Technical change to M12 nut with additional hexagonal mounting

| - | Product change notification number: | PCN-PB46-20180606-00-A |

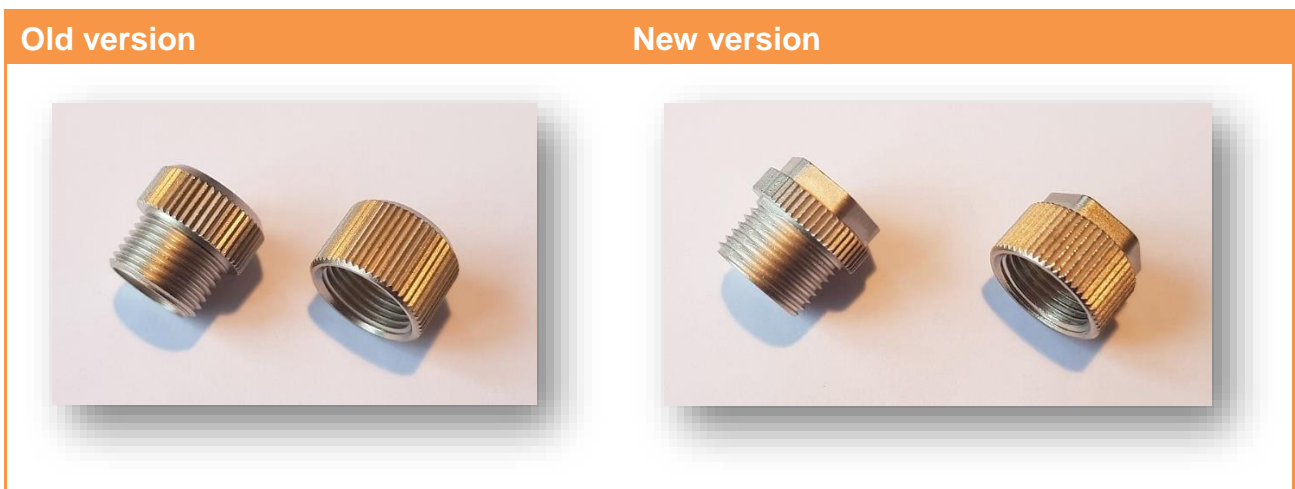
The M12 nut has a complete knurling.

Additional to the knurling the new M12 nut has a hexagonal mounting, with the wrench size 12mm.

Improve of the M12 nut handling due to the additional option to fasten the M12 nut with interchangeable blade with wrench size 12mm. The Screwty® can still be used as usual, the suitable interchangeable blade with wrench size 12mm is the 2598970000.
